Docket Item # 2
BAR CASE # 2011-0094

BAR Meeting
May 25, 2011

ISSUES: After-the-fact removal of planter box, awning and chain-link gate;
Installation of new, planter box and removal of fence

LOCATION: 1603 Princess Street

Figure 11: Proposed drawing and color selection of new planter box.

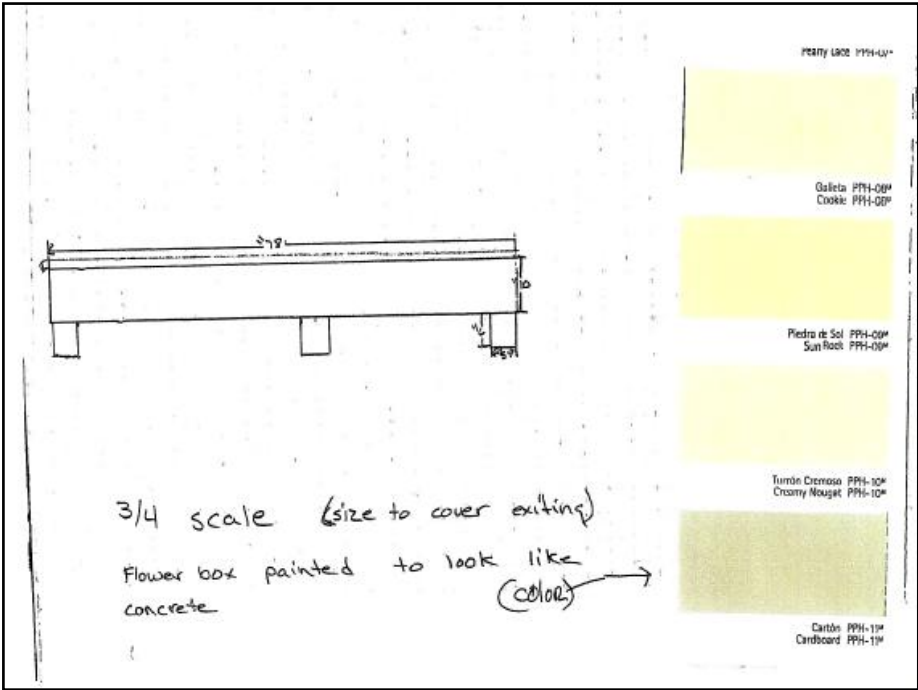
Staff supports the replacement of the cast concrete planter box with one made of fiberglass and painted a color to resemble concrete. Replacing it allows for the visual representation of an important character defining feature and provides a more finished appearance to the façade.

Staff also feels that the paint should have a textured finish to simulate a concrete like finish. The planter box should match the same size and scale of the original planter box as closely as possible. It should also be mounted through the mortar joints or remains of cast concrete and not the brick.

C-2 A detail of the material and method of attachment of the flower box will be required to be submitted for review prior to the issuance of the permit.

1. That the metal hardware is carefully removed from the cast concrete lintel and all damage from the removal of the metal awnings be repaired.
2. That a textured, sand-like finish be applied to the paint of the replacement planter box to simulate a concrete-like finish.
3. That the new planter box is mounted through the mortar joints or remains of cast concrete and not the brick.
4. That the chain-link fence in front of the property be repaired and retained.
5. That the chain-link gate and gate crest be replaced, with Staff having final approval of replacement.
